NUMBER 116

SUBJECT: Battery Box Lid

MODELS AFFECTED: Piper Model PA-20 Serial Numbers 20-553 thru 20-600 incl., 20-602 thru 20-623 incl., 20-627 thru 20-631 incl., 20-633 thru 20-641 incl., 20-643 thru 20-649 incl., 20-651, 20-654, 20-656, 20-660 and 20-662, also, Model PA-22 Serial Numbers 22-1 thru 22-33 incl., 22-35 thru 22-37 incl., 22-43, 22-51, 22-53 and 22-54.

SKETCH #1

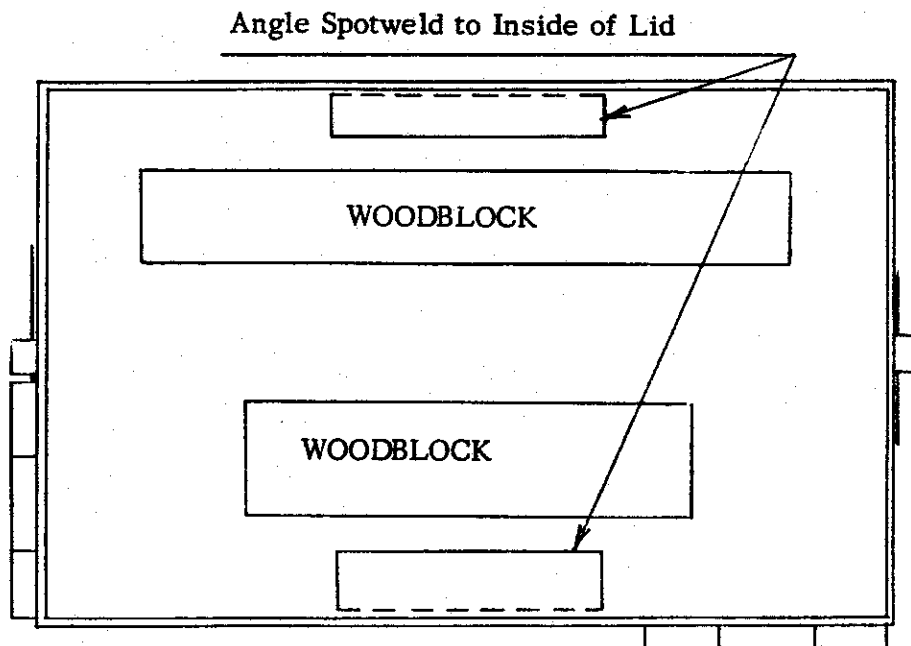
Lids of the type construction shown in Sketch No. 1 are satisfactory without rework.

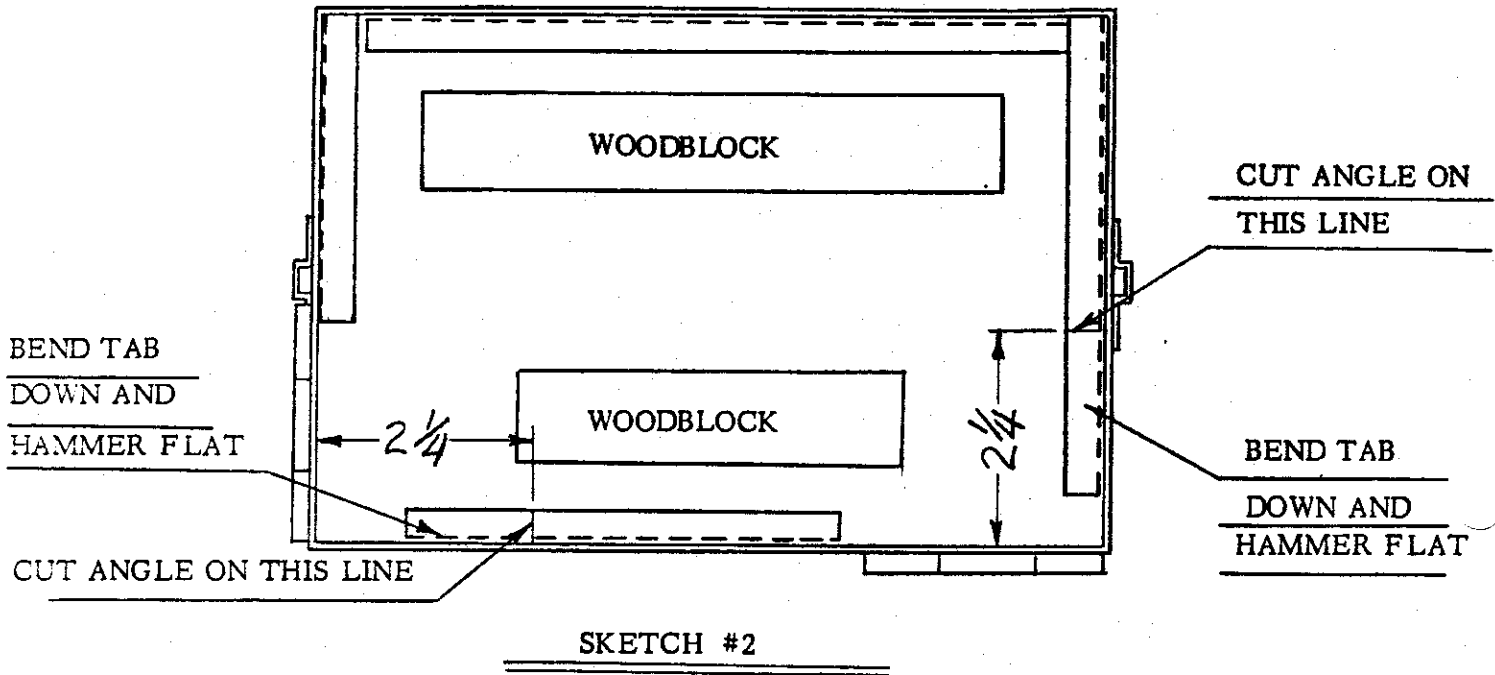
FOUR ANGLES SPOTWELD TO INSIDE OF LID

Lids of the type construction shown in Sketch No. 2 must be reworked as indicated.
